DOCKETS 50-266 AND 50-301  
TECHNICAL SPECIFICATION CHANGE REQUEST 192  
MODIFICATIONS TO TECHNICAL SPECIFICATIONS 15.3.3  
"EMERGENCY CORE COOLING SYSTEM, AUXILIARY COOLING SYSTEMS,  
AIR RECIRCULATION FAN COOLERS, AND CONTAINMENT SPRAY"  
15.3.7 "AUXILIARY ELECTRICAL SYSTEMS" AND 15.5.2 "CONTAINMENT"  
POINT BEACH NUCLEAR PLANT, UNITS 1 AND 2

### TECHNICAL SPECIFICATION CHANGE REQUEST 192 DESCRIPTION OF PROPOSED CHANGES

ATTACHMENT 2  
**TECHNICAL SPECIFICATION CHANGE REQUEST 192**  
**SAFETY EVALUATION**

Figure 1

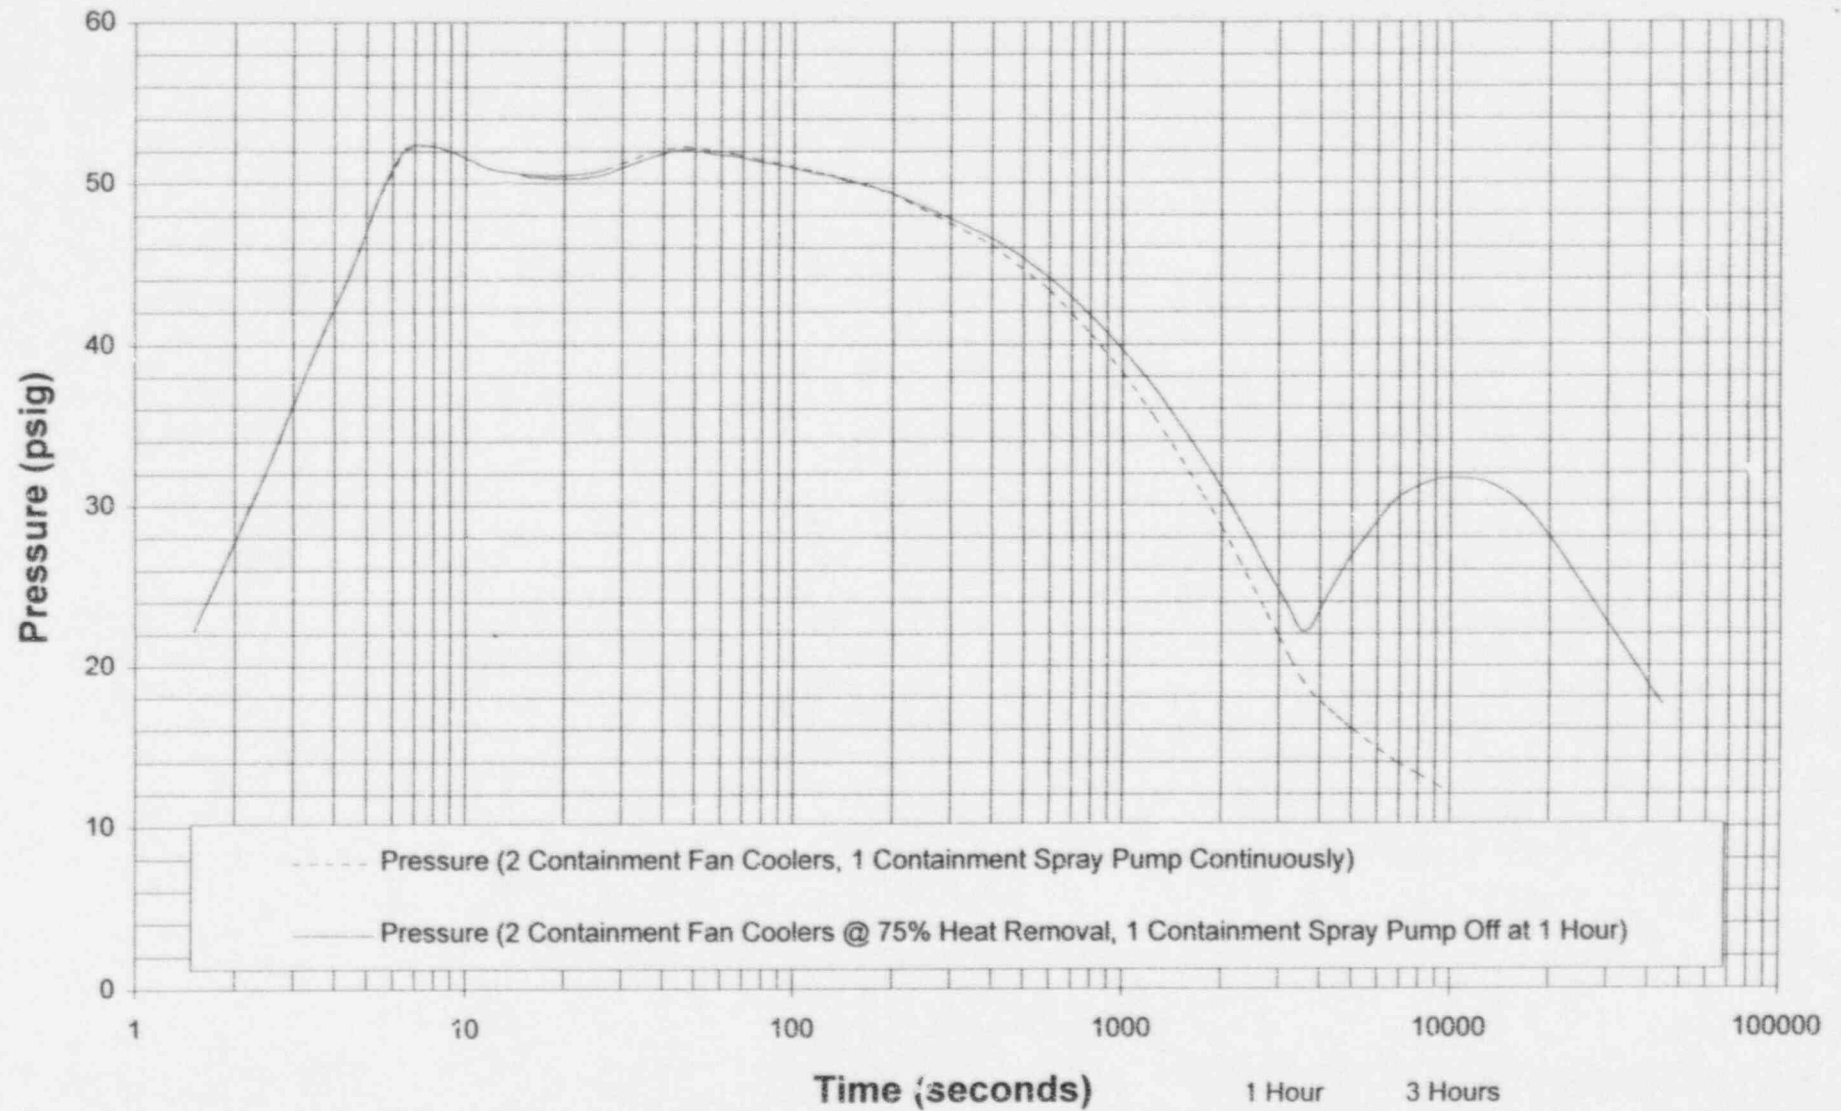
The results of the Westinghouse evaluation are shown graphically in the attached figures. Figure 1 is the containment pressure response and Figure 2 is the containment temperature response. Each figure compares the current FSAR case (two fan coolers and one spray pump operating throughout the event) to the reduced cooling case (spray termination at one hour; two fan coolers at 75% heat removal). The results show that the peak containment pressure is approximately 53 psig for both cases (well below the 60 psig containment design pressure), and the peak occurs prior to any heat removal by the fans and sprays for both cases. Therefore, peak containment pressure following a LOCA is unaffected by the reduced containment heat removal rate assumed in the evaluation.

Reducing the rate of containment heat removal by spray and fan coolers changes the shape of the containment pressure and temperature profiles. Figures 1 and 2 show that the overall impact of terminating spray at one hour and running two fan coolers with reduced heat removal is a more gradual depressurization to the one hour point, a small increase in pressure and temperature when sprays are secured at one hour, and a more gradual depressurization thereafter, compared to the original FSAR case with two fan coolers and one spray pump operating throughout the event.

The pressure profile in Figure 1 shows that containment pressure does not reach 60 psig, and will decay to less than 15 psig in the first 24 hours, which will limit the leakage to a rate at or below the assumptions of the dose analyses. The dose releases that would result from the revised pressure profile are therefore enveloped by the worst-case releases that have already been documented in the FSAR and found to be acceptable.

When the worst-case accumulator pressure decay profile is superimposed on the revised containment pressure profile in Figure 1, it can be seen that the T-ring seals will be supplied with air at a pressure above containment pressure throughout the analyzed duration of the transient. A positive seal pressure relative to containment pressure will maintain containment purge valve seal integrity. Therefore, the ability of the purge valve seals to support the containment isolation function will not be impaired by the revised containment pressure response shown in Figure 1.
